CHANGE ORDER

Project Name: **Haverhill Consentino Middle School** CO No.

Architect's Project No. **21-0818**

See attached list of 8 item(s) for a total of**\$55,398.36**

① SECOND FLOOR PLAN - AREA B - PIPING

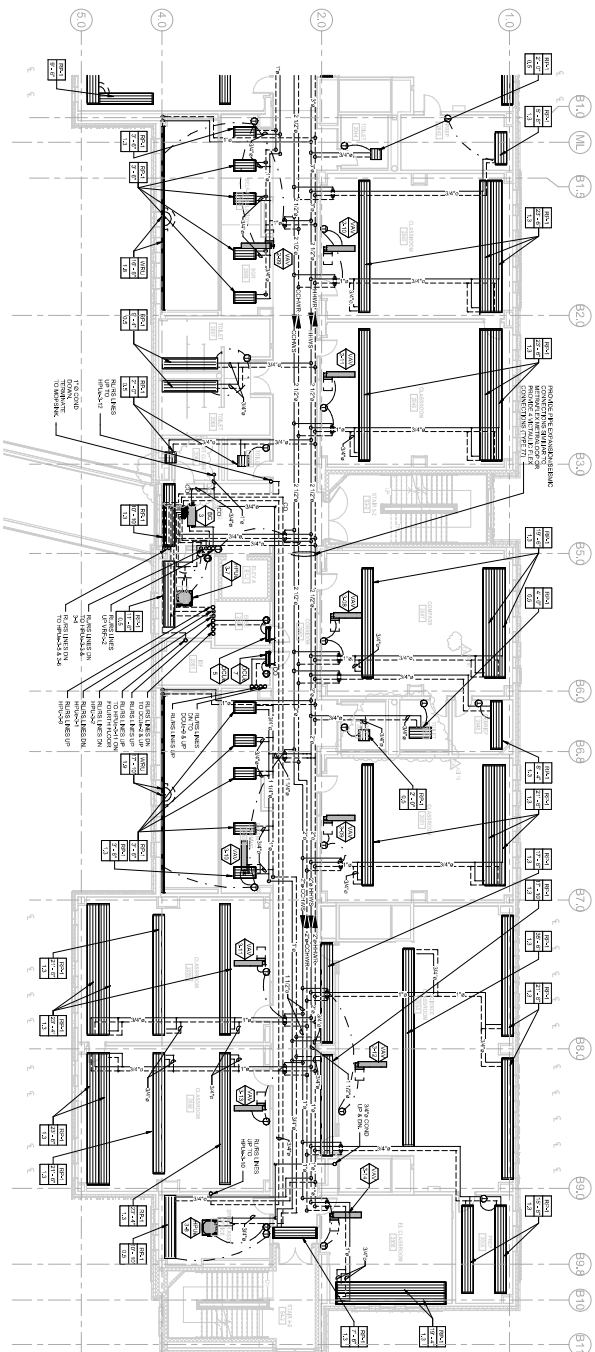
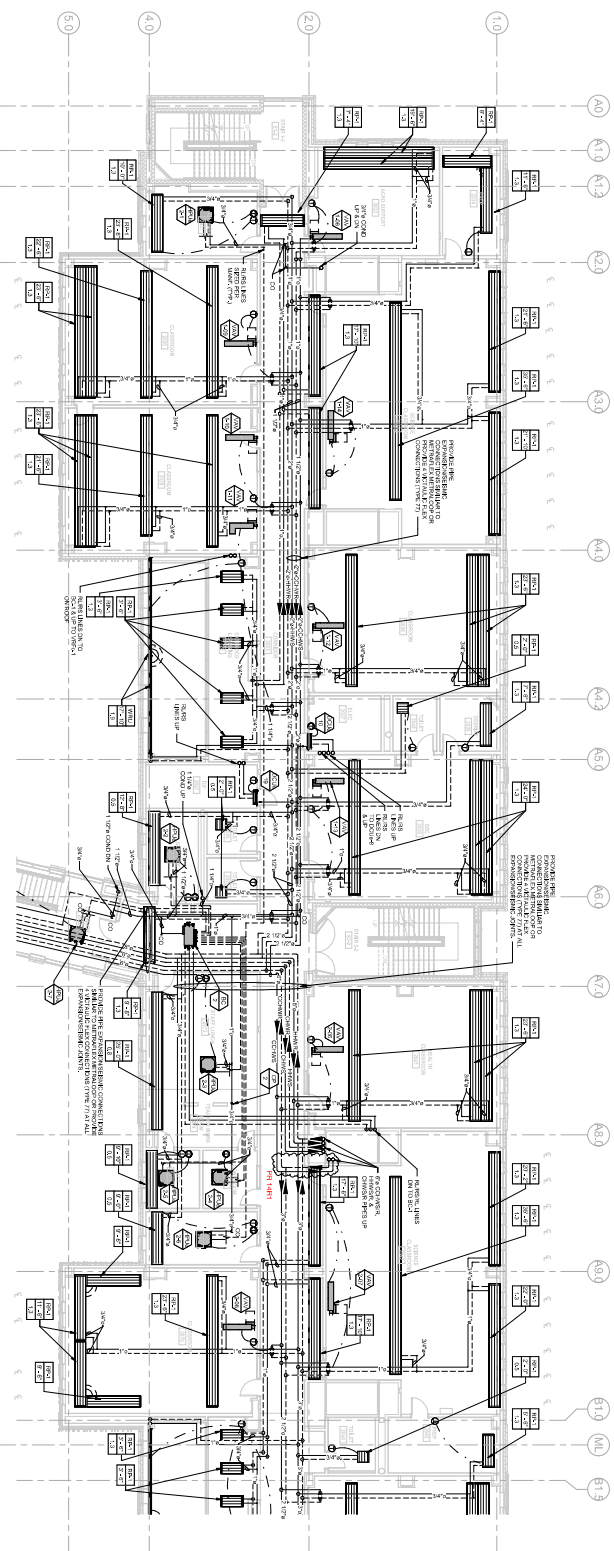
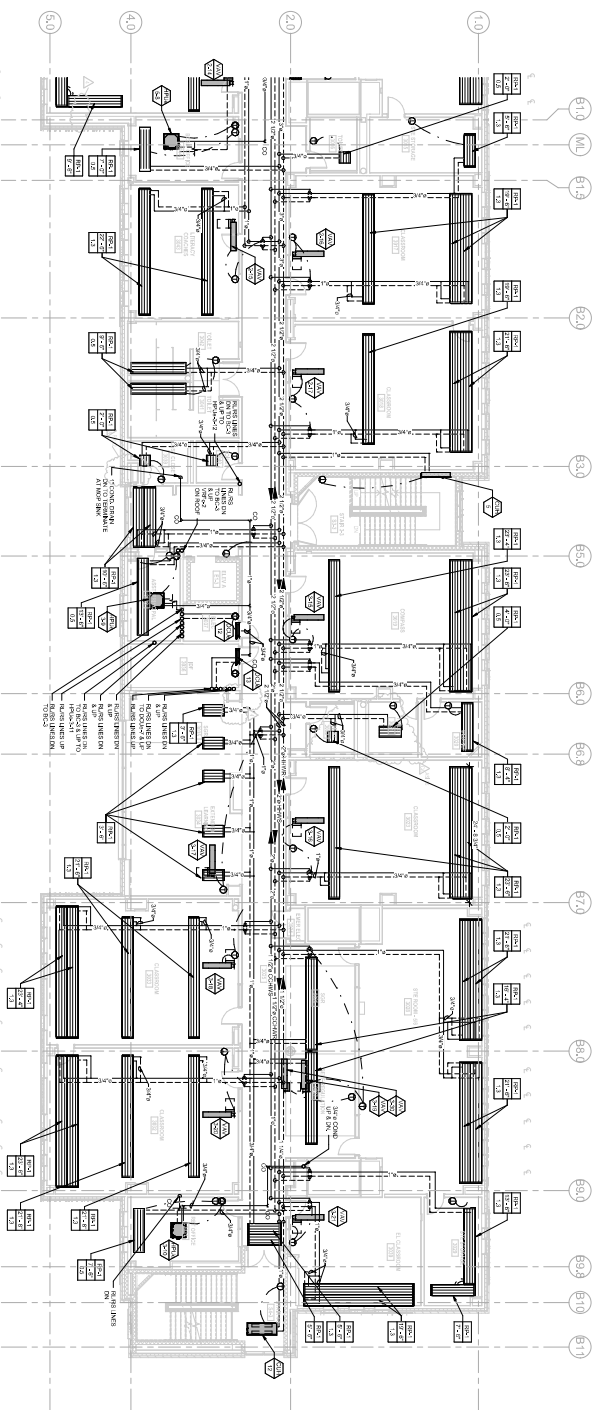
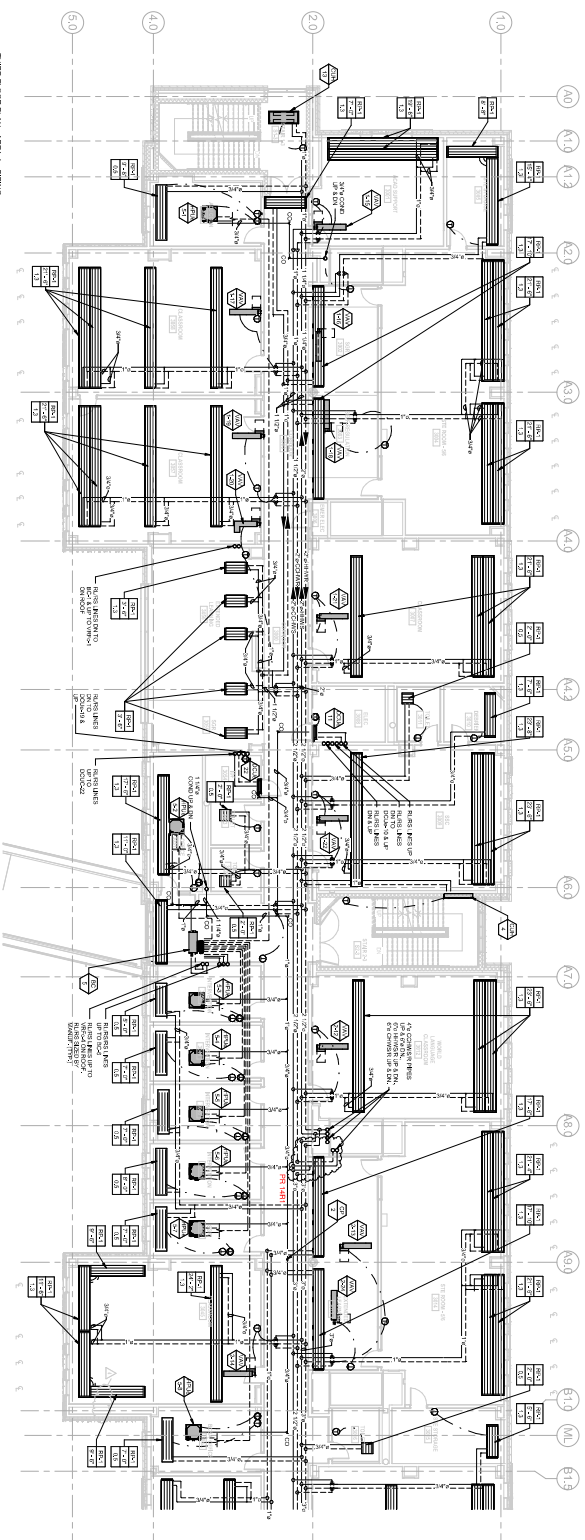
To coordinate the contract documents with RFI 058 and follow up RFI 093, make the following revisions:

At Sheet M2.21, HVAC – Second Floor plan – Area A / B Piping, M2.31, HVAC – Third Floor Plan – Area A / B Piping and M2.41, HVAC – Fourth Floor Plan – Area A / B Piping, revise piping as shown on the attached sheets.

Refer to attached updated drawings with the relocation of the CCHW piping as requested per RFI 93. The attached drawings previously provided HHW and CHW in one chase area, and the relocated CCHW in the main shaft per GMC's proposed solution within their RFI #093.
